Access Compliance Report

Public Rights-of-Way

Intersection ID: 12680	Main Street: W_MOREHEAD_ST	Cross Street: S_MINT_ST	Location:	N
ADA ID: 0597CC89F5B1	Ramp Type: PerpDiag	Initial Pass/Fail: Fail	Overall Compliance: No	Severity Score: 35

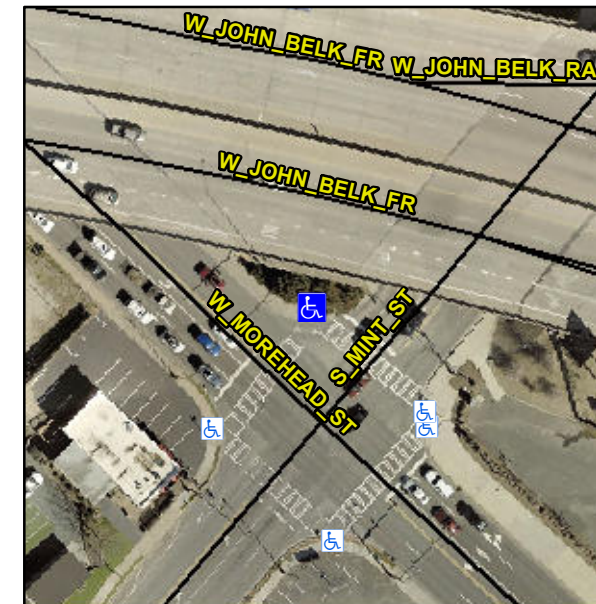
Not Found, R304.5.1, R304.2.2, R304.5.3

Compliance	Description	Data	Compliance	Description	Data
N/A	Ramp Length (in)	32.0	No	Ramp Slope (%)	13.4
No	Ramp Width (in)	41.0	No	Ramp XSlope (%)	2.5
N/A	Flare Type LT	N/A	N/A	Flare Type RT	N/A
N/A	Flare Slope LT (%)	N/A	N/A	Flare Slope RT (%)	N/A
N/A	Flare Traversable LT?	N/A	N/A	Flare Traversable RT?	N/A
N/A	Landing Length (in)	N/A	N/A	DWS Provided?	N/A
N/A	Landing Width (in)	N/A	N/A	DWS Contrast?	N/A
N/A	Landing Slope (%)	N/A	N/A	DWS Length (in)	N/A
N/A	Landing X Slope (%)	N/A	N/A	DWS Full Width?	N/A
N/A	Landing Curb? (Y/N)	N/A	N/A	DWS Offset (in)	N/A
N/A	Shared Landing?	N/A			
N/A	Gutter Ponding?	N/A	N/A	Gutter Slope (%)	N/A
N/A	Gutter Lip Ht (in)	N/A	N/A	Gutter X Slope (%)	N/A
N/A	Painted X Walk1?	Yes	N/A	Painted X Walk2?	Yes
	X Walk 1 Direction	To SW		X Walk 2 Direction	To SE
N/A	X Walk 1 Width (in)	108.0	N/A	X Walk 2 Width (in)	92.0
	X Walk 1 Slope (%)	0.5		X Walk 2 Slope (%)	2.8
	X Walk 1 X Slope (%)	2.8		X Walk 2 X Slope (%)	0.5

Remove & Replace Curb Ramp With Two New Directional Ramps or Equivalent.
